APPLICATION NO.	FILING DATE	FIRST NAMED INVENTOR	ATTORNEY DOCKET NO.	CONFIRMATION NO.
10/809,336	03/26/2004	Cecilia DeVenezia	DV-04	9525
47728	7590	07/07/2006	EXAMINER	
THOMAS J. GERMINARIO, ESQ. 154 ROUTE 206 CHESTER, NJ 07930			HAWK, NOAH CHANDLER	
			ART UNIT	PAPER NUMBER
			3636

Office Action Summary	Application No.	Applicant(s)	
	10/809,336	DEVENEZIA ET AL.	
	Examiner	Art Unit	
	Noah C. Hawk	3636

DETAILED ACTION

Chan et al., Figure 2

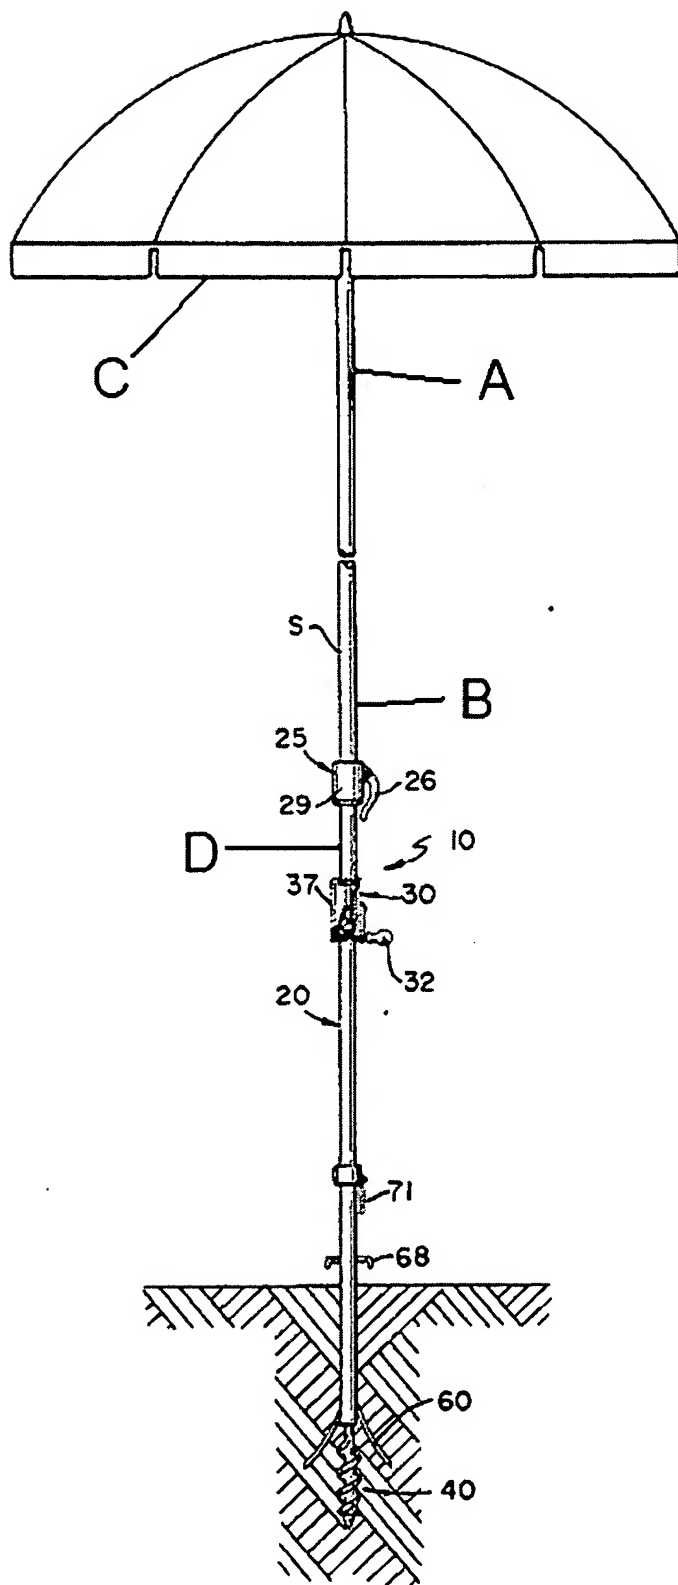
Chan et al. teaches a rotating power tool having a variable speed DC electric motor (12) with a double pole-double throw switch (22, see Chan, Column 2, lines 49-57: a "DPDT switch" is considered in this case to be a double-pole-double-throw switch) which regulates the direction of the motor by the direction of the pressure applied to the switch with a rheostat element to regulate the speed of the motor (a "speed control circuit" is considered in this case to be functionally equivalent to a rheostat.). Chan further teaches that the tool has a handle (section Z of the tool, best seen below) attached to the motor element, that the switch is mounted on the handle and that the switch is a positive action switch. It would have been obvious to one of ordinary skill in the art at the time of invention to modify the umbrella of Jacinto et al., as modified, by using a motor with a handle having a pressure and direction sensitive switch mounted on its handle as taught by Chan et al. in order to allow the user to control the rotation of the auger more precisely. Please note: although Jacinto and Chan are silent on which direction the motor rotates, it would be obvious that when the motor is engaged to turn in the "forward" direction, the auger would be driven in such a way as to insert itself into the ground, whether it was a clockwise-wound helix or a counterclockwise-wound helix.

Likewise, it would be obvious that when the motor is engaged to turn in the “reverse” direction, the auger would be driven in such a way as to extricate itself from the ground.

Jacinto et al. Figure 1

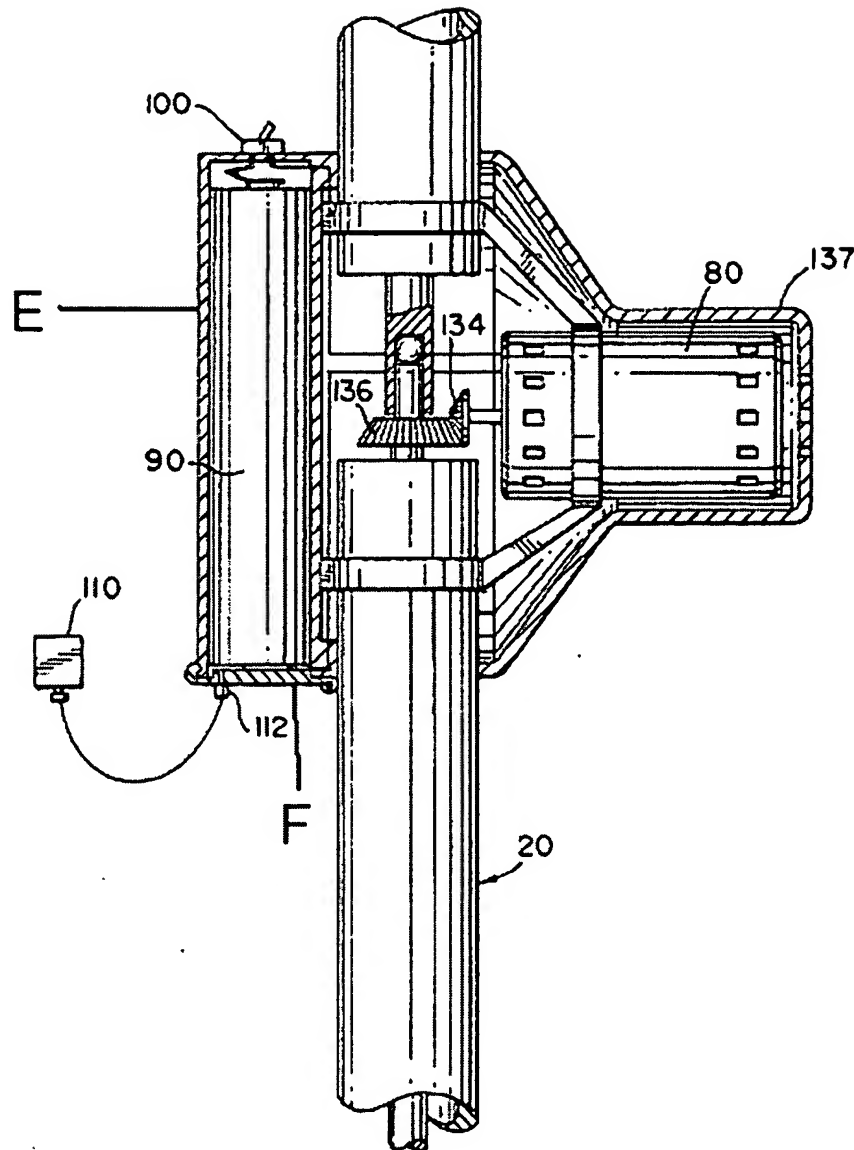
4. Claims 1-5 are rejected under 35 U.S.C. 103(a) as being unpatentable over Jacinto et al. in US Patent 5152495 in view of Doreste in US Patent 6267127 and Chan et al. in US Patent 5525889. Jacinto teaches a self anchoring beach umbrella having a canopy member having an upper tubular element (A) with a spreadable canopy (C) and a lower tubular element (B); a pole member (20) having an upper element (D) and a motor element (137) comprising a DC electric motor (137, the fact that the motor receives power from the battery 90 is sufficient to consider it a DC motor) having on its lower end an axially-disposed shaft (35) through which a rotary torque is generated when the motor is activated and an auger (40) having a cylindrical axis (45) and helical flighting coupled to the shaft of the electric motor; a battery chamber (E) located in or mounted upon the pole member, said battery chamber having within it one or more batteries (90) and having a means (F) for accessing said batteries so that they may be removed and replaced or recharged; a switch (100) mounted on the motor element of the pole member and electrically connected to the batteries, whereby the motor may be activated and the direction and speed of the motor may be controlled. Jacinto et al. do not teach an axial lumen in the lower tubular element, an upper element for insertion therein, that the motor is reversible or that the device has a handle on the motor with a pressure sensitive, directional switch. Doreste teaches a beach umbrella device with a canopy member (12) having a lower tubular element (20) within which is formed an axial lumen (26) as well as a pole member (50) having an upper element (52) formed for insertion into the axial lumen of the canopy member. It would have been obvious to one

of ordinary skill in the art at the time of invention to modify the device of Jacinto et al. by using an axial lumen in the lower tubular element to receive an upper element formed for insertion therein as taught by Doreste in order to allow the canopy member to be more easily separated from the pole member. Jacinto et al., as modified does not teach a reversible electric motor or a handle with a pressure sensitive, directional switch.

Campomar, Figure 3

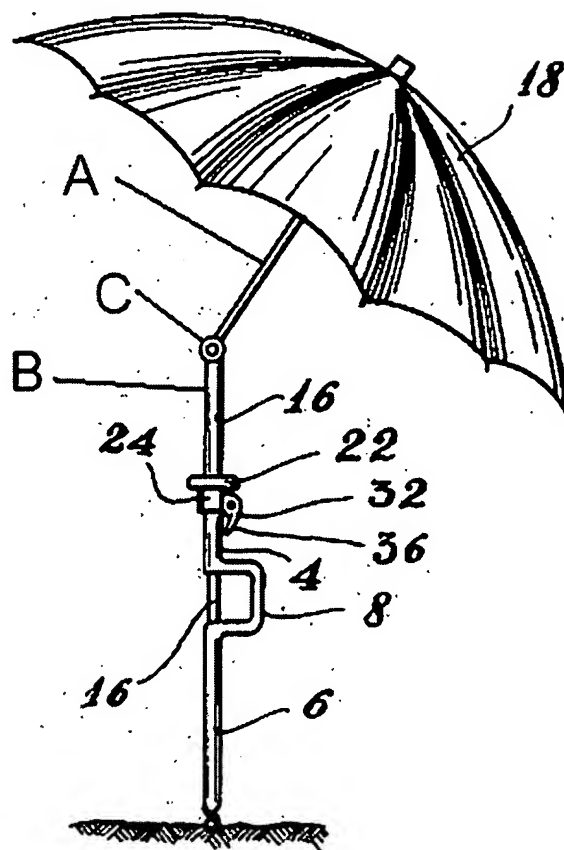
6. Claims 7 and 8 are rejected under 35 U.S.C. 103(a) as being unpatentable over Jacinto et al., as modified, and further in view of Campomar in US Patent 2628797. As stated above, Jacinto et al., as modified fails to teach a tilting umbrella. Campomar teaches an auger-anchored umbrella with a joint means (C) disposed between the upper (A) and lower (B) tubular elements for tilting the upper tubular element of the canopy about an axis with respect to the lower tubular element. It would have been obvious to one of ordinary skill in the art at the time of invention to modify the device of Jacinto et al., as modified, by using a tilting umbrella as taught by Campomar in order to change the position of the umbrella without changing the anchor position.
